# CHRIST CHURCH OF ORLANDO 2200 S. ORANGE AVE.

The applicant is requesting a Conditional Use Permit (CUP) for the expansion of a Public Benefit Use (a church) as well as to allow accessory parking in the R-3B/T zoning district. The church expansion is multi-phased and therefore the request includes Master Plan review as well.

## Appendix A All Conditions For Case #: CUP2014-00007

SITE PLAN

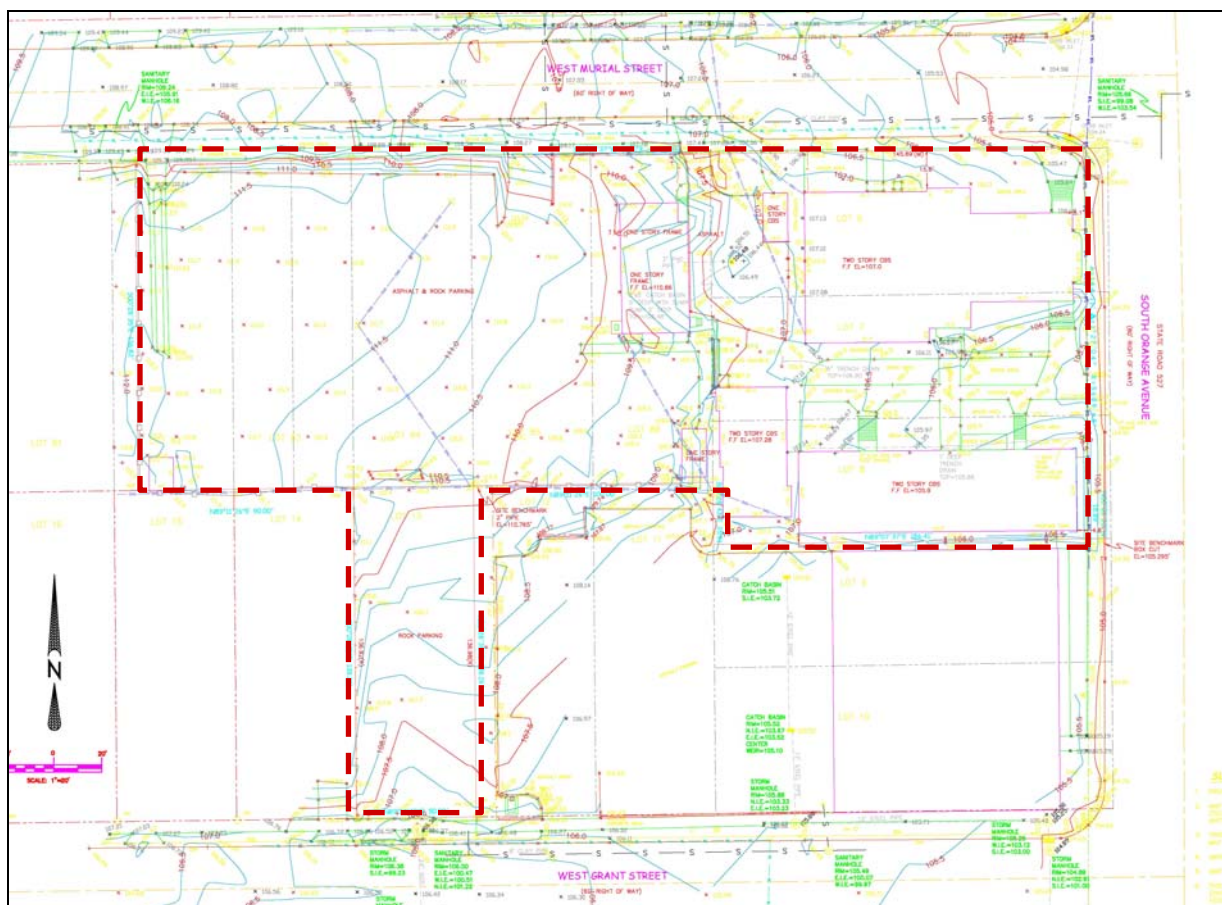
Parking to be shared by both the church and medical complex. Site is currently a gravel lot but is proposed to be paved.

10. Paved Parking. The northernmost parking lot shall be paved. Parking on unimproved surfaces shall be prohibited due to its use by the medical complex and no longer being rendered as occasional parking.		
<b>Urban Design</b>			
	U900URBAN DESIGN	6/25/2014	M E. Petion
	Urban Design		
	For questions regarding Urban Design Review, please contact Doug Metzger at 407.246.3414 or douglas.metzger@cityoforlando.net.		
	North Parking Lot

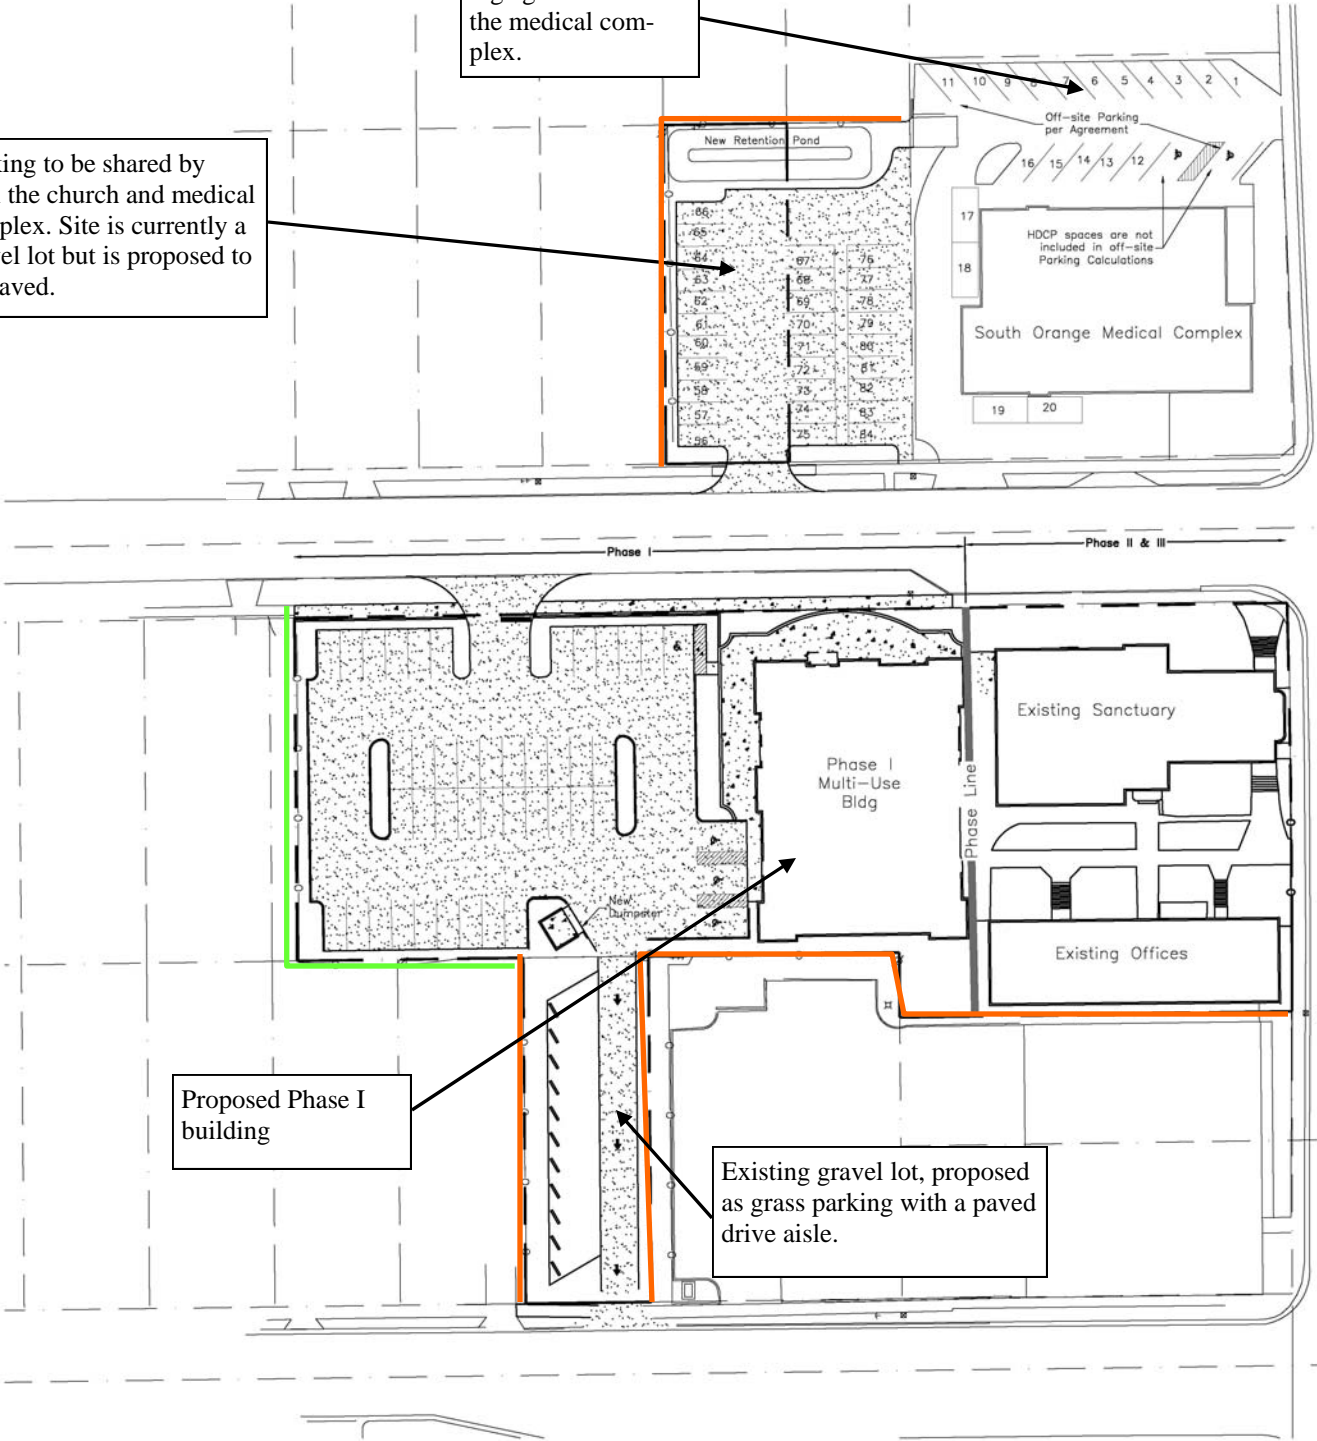
Owner has a parking agreement with the medical complex.

- Bufferyard A required
- Bufferyard B required

6. Bufferyard. A 6 ft tall masonry wall shall be required with all bufferyards. Bufferyard B shall be permitted at a minimum width of 5 ft.			
7. ISR. Please provide ISR calculations consistent with the two zoning designations. R-3B/T is limited to 70% and MU-1/T is limited to 85%.
